## Memorandum

**RE: *Planning Review # 1***  
***Application # PB 2018-29***  
***220-232 West Front Street***  
***Applicant: Front Street Offices Urban Renewal, LLC***  
***Block 249, Lot 6.01***  
***Zone: Teepers Tract Redevelopment Plan***

**RE: Engineering Review #1  
Front Street Offices Urban Renewal, LLC  
220-232 West Front Street  
Block 249, Lot 6.01  
Application #: PB 2018-29**

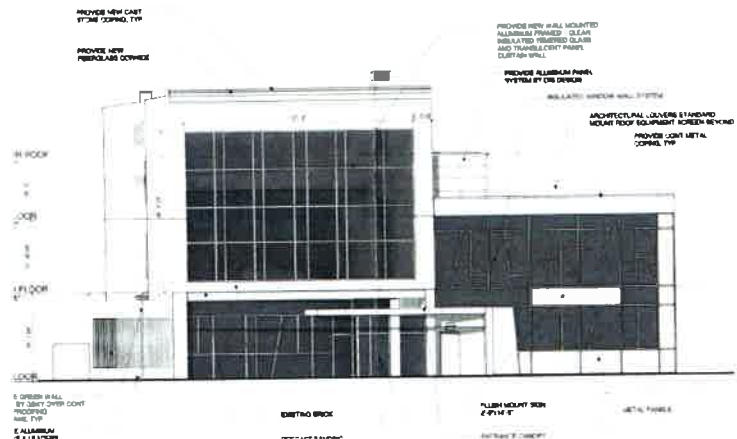
- (i) All building foundations shall be appropriately landscaped. **This requirement is not met and a variance is required.** Applicant is proposing one (1) shade tree along the front exterior of the building and extensive landscaping to the rear. In addition, applicant is proposing green wall panels along the front and side elevations of the building. Additional details regarding maintenance and feasibility of these green walls should be provided.
